# UNITED STATES PATENT AND TRADEMARK OFFICE

APPLICATION NO.	FILING DATE	FIRST NAMED INVENTOR	ATTORNEY DOCKET NO.	CONFIRMATION NO.
10/693,195	10/24/2003	Randall R. Geib	0241-P03282US0	2326
110	7590	03/02/2006	EXAMINER	
DANN, DORFMAN, HERRELL & SKILLMAN 1601 MARKET STREET SUITE 2400 PHILADELPHIA, PA 19103-2307			GARCIA, ERNESTO	
			ART UNIT	PAPER NUMBER
			3679

## Office Action Summary

## DETAILED ACTION

Applicant's Marked-up Figure 2

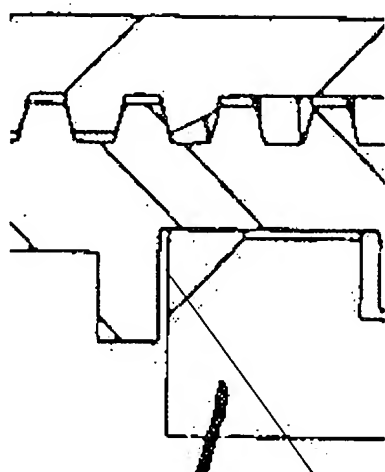
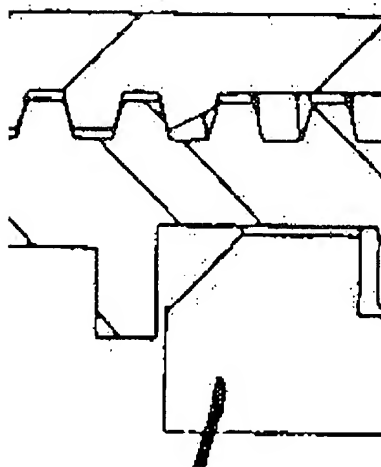
The drawings are objected to because the cross sectional view of the chamfered surface (unreferenced) of the flange 55 is not shown accurately. See attachment of marked-up Figure 2 to find the error in the cross sectional view. Applicant argues that the chamfers are correct; however, the examiner disagrees. Applicant should review the blown-up details in the attachment provided to see the difference between the error and what the drawing must show.

Incorrect

Line must be  
deleted on both  
top and bottom  
chamfers of  
Figure 2

Correct

Notice that the  
proper cross-  
section of the  
chamfer is correct
